Multichannel Network Interface Controller for HDLC with Extensions MUNICH32X

PEB 20321 Version 2.2

Delta Sheet 06.98

This Delta Sheet describes the differences between MUNICH32X Version 2.2 and MUNICH32X V1.2 (Data Sheet 05.97).

Figure 52

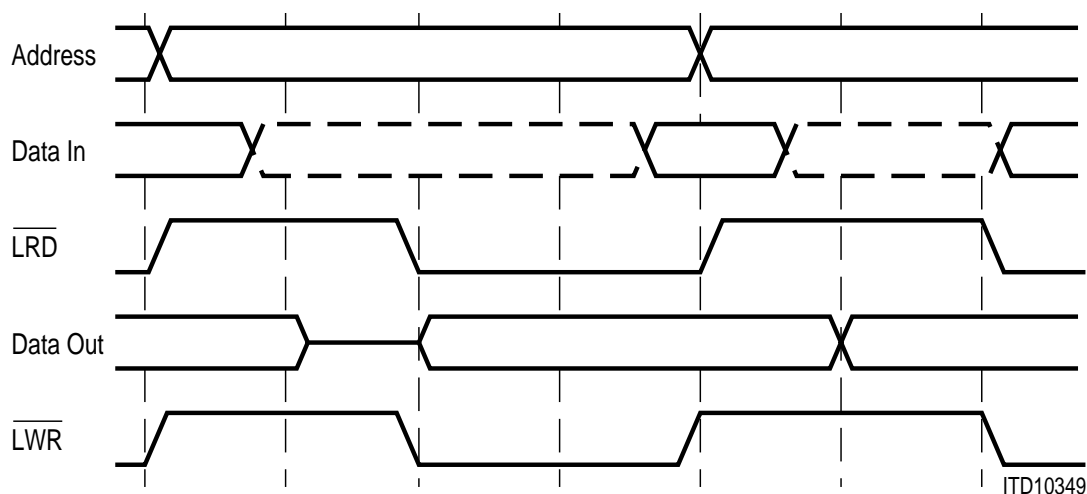
Although this signal was generated by MUNICH32X Version 1.x independent of the selected bus mode it is obsolete and thus **not supported by MUNICH32X V2.2 in De-multiplexed Bus Mode**.

Signal LALE is deleted from figure 52 describing the de-multiplexed bus cycle.
